Proposed change of STP effluent discharge Kogan Creek Power Station

Kogan Creek Power Project STP treated effluent discharge amendment

Inspection Details

Petroleum storage container 2.jpg

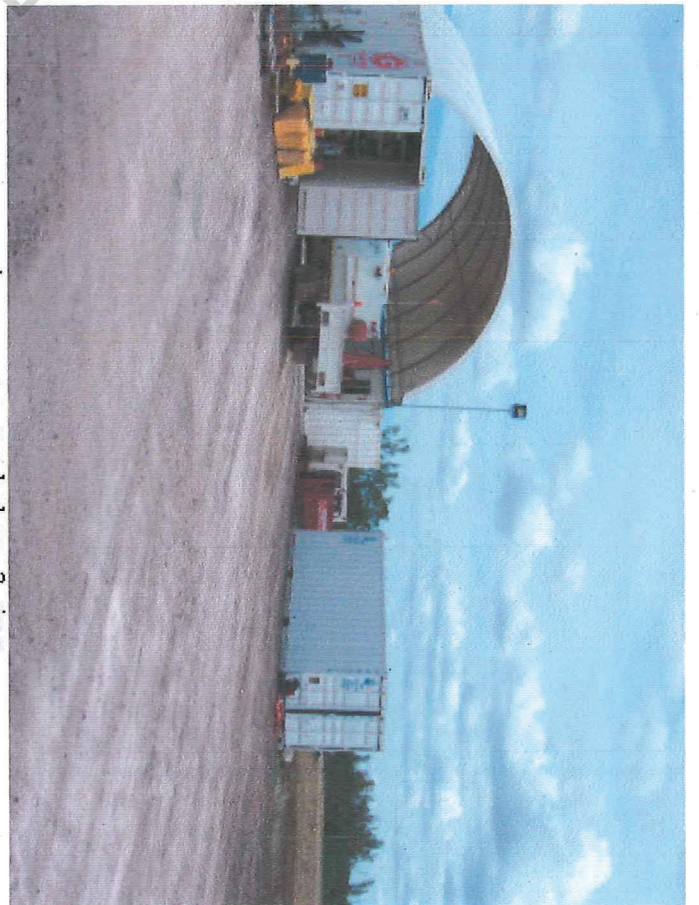
Most petroleum products are banded however there were some 200L stored uncovered and not banded in accordance with condition A4-1.

All flammable and combustible liquids must be maintained in accordance with section 5.9 of Australian Standard 1940. A temporary bunding system must be implemented for the storage of these products whilst the workshop is being constructed.

Two extra self bundled pallets have been purchased and the drums are now stored on these pallets (the majority of the drums on the ground during your visit were empty and have now been disposed of).

effluent irrigation area.jpg

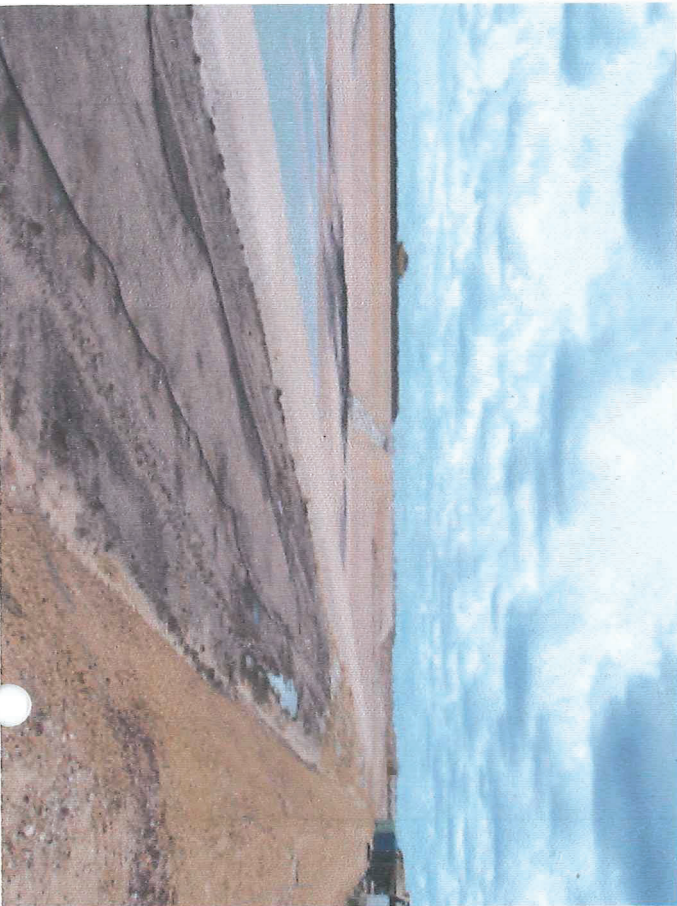
Treated wastewater from the sewage treatment plant is being irrigated onto soil adjacent to the plant. There is a sign indicating that the area is being irrigated with treated wastewater. This ground is not vegetated, which may result in treated wastewater ponding on the surface or potentially moving off site.

A system needs to be implemented that would ensure treated wastewater does not have the potential to move off site and a method of nutrient removal, for example growing vegetation.

A bund has been placed at the end of the treated water area to stop the water escaping this area. (note the water in the photo is from the 37mm of rain we had last week). We are in the process of ordering the grass seed for the levee bank and we will also seed the treated water area with this in the near future (80% Rhodes, 10% blue grass, 10% premier digitaria. The photo shows that there is grass starting to grow in this area naturally.
